[Docket No. 97-SW-59-AD; Amendment 39-11235; AD 99-15-14]

#### Airworthiness Directives; Sikorsky Aircraft-Manufactured Model CH-54B Helicopters

**ACTION:** Final rule.

##### **AD 99-15-14 Blue Bird Helicopters:**

Borecope Inspection of Second Stage  
Lower Planetary Plate Lightning Holes  
Figure 1

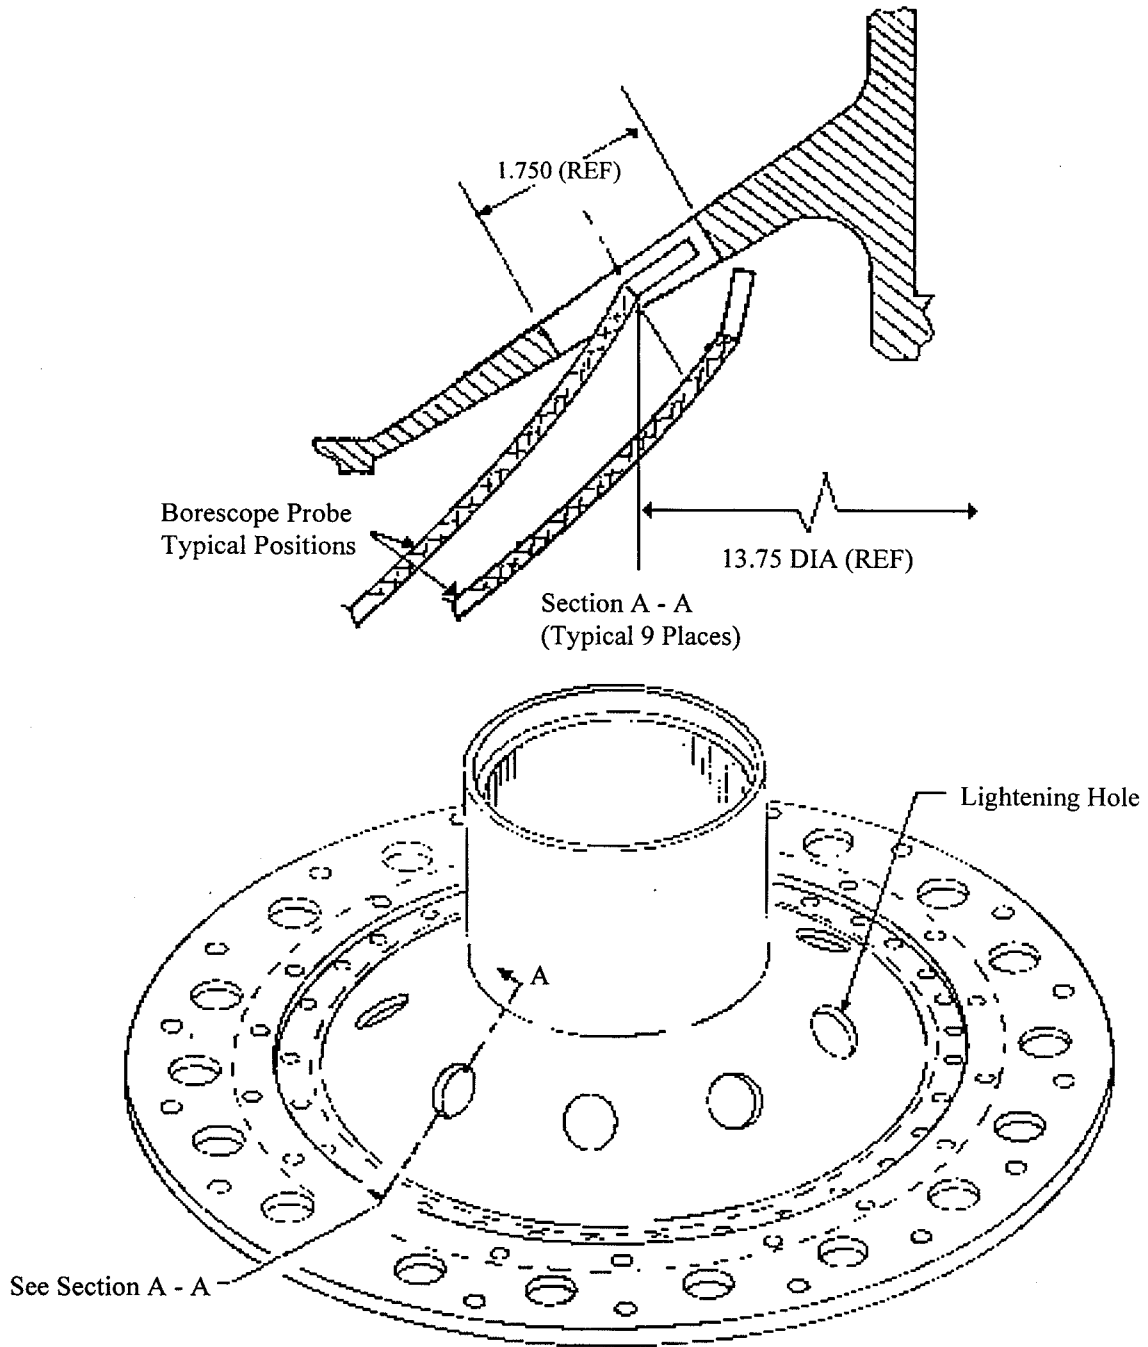
(2) Within the next 100 hours TIS after the effective date of this AD, and thereafter at intervals not to exceed 200 hours TIS, conduct a borescope inspection of the plate for cracks in the area of the nine lightening holes (see Figure 1). If a crack is found, replace the plate with an airworthy plate. The plate, P/N 6435-20516-101, is part of the main gearbox second stage planetary set (P/N 6435-20514-041), which is a serialized matched set, and must be replaced as a set.

Rework of Second Stage Lower Planetary Plate  
Figure 2

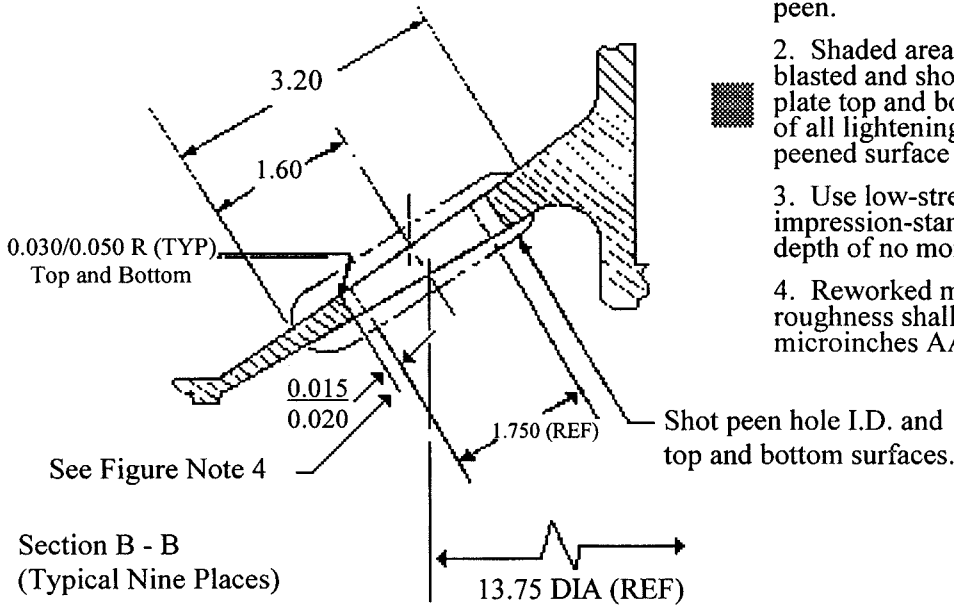
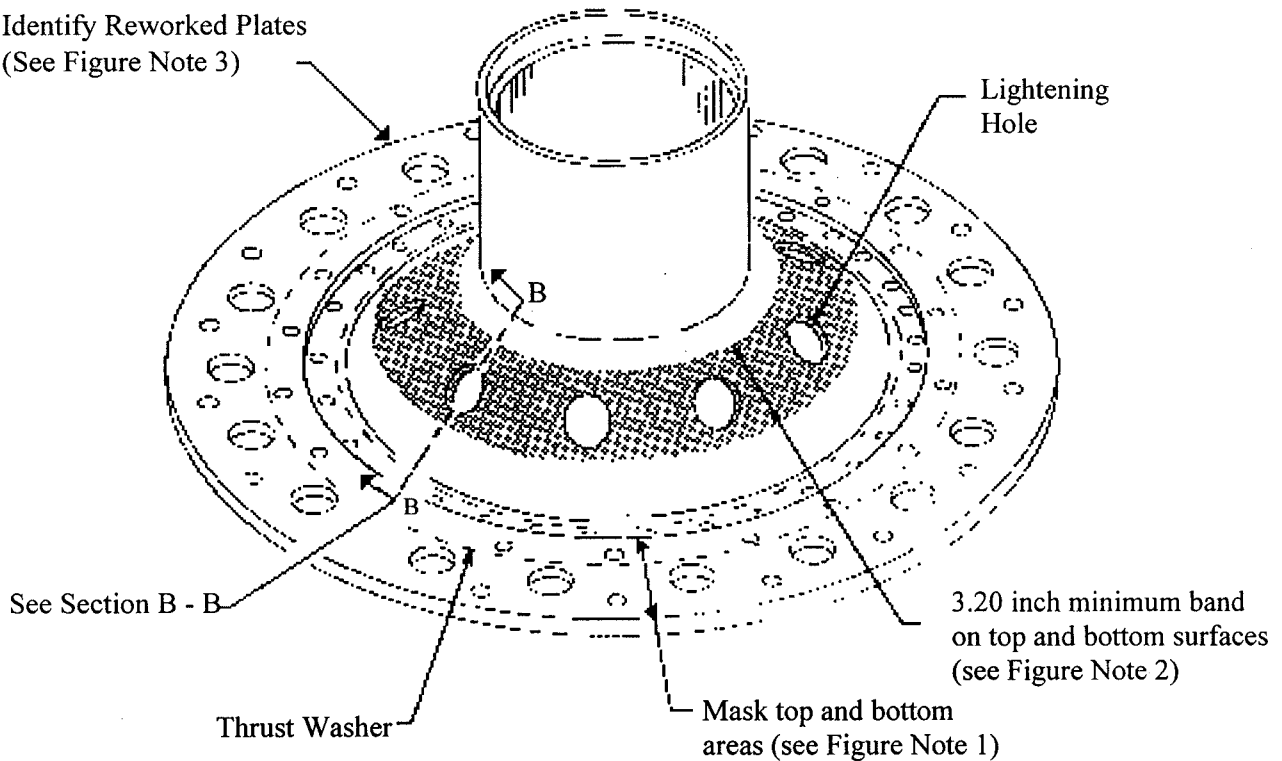
(i) Measuring from the center of each 1.750-inch diameter lightening hole, machine 0.015/0.020 inch from the radius of the hole (see Figure 2). Machined surface roughness shall not exceed 63 microinches AA rating.

(A) Mask the top and bottom of the plate leaving exposed a 3.20-inch minimum circumferential band centered on 13.75-inch diameter of plate (see Figure 2). Mask the area to protect the thrust washer and the surrounding areas from vapor blast.

(v) Identify the reworked plate by stamping the number of this AD after the part number. Use a low-stress depth-controlled impression-stamp with full fillet depth of no more than 0.003 inch (see Figure 2). Marking must be such that it cannot be construed as part of the part number.

1. Mask top and bottom areas to protect from liquid air-grit and shot peen.
2. Shaded area to be liquid air-grit blasted and shot peened includes plate top and bottom surfaces and I.D. of all lightening holes. Feather shot peened surface edges.
3. Use low-stress depth controlled impression-stamp with full fillet depth of no more than 0.003 inch.
4. Reworked machined surface roughness shall not exceed 63 microinches AA rating.

Identify Reworked Plates  
(See Figure Note 3)
